Informal Ad hoc Expert Group on Conceptual and
Technical aspects of Computerization of the TIR Procedure
(26-27 May 2005)

IRU and Association's comments on Version 1.4a of the Reference Model

Transmitted by the IRU

1. Chapter 0.2.3, page 12:

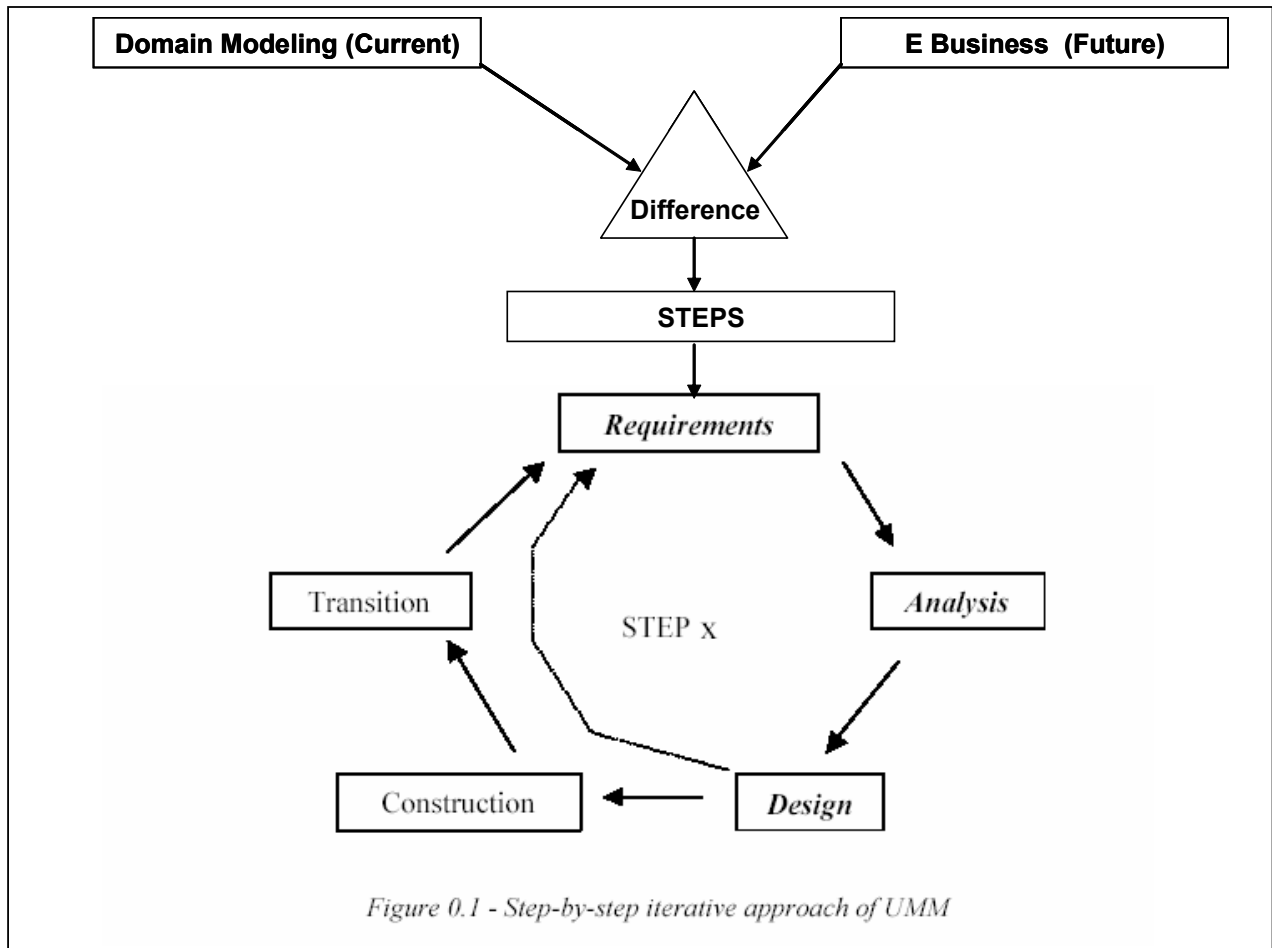
Replace existing figure 0.1 with following figure:

The proposed scheme illustrates a more pragmatic approach by:

- comparing the needs and requirements (E Business future) with the existing system;
- define the difference, which is what still must be developed or modified;
- define the steps based on the difference, and according to stakeholder priorities.
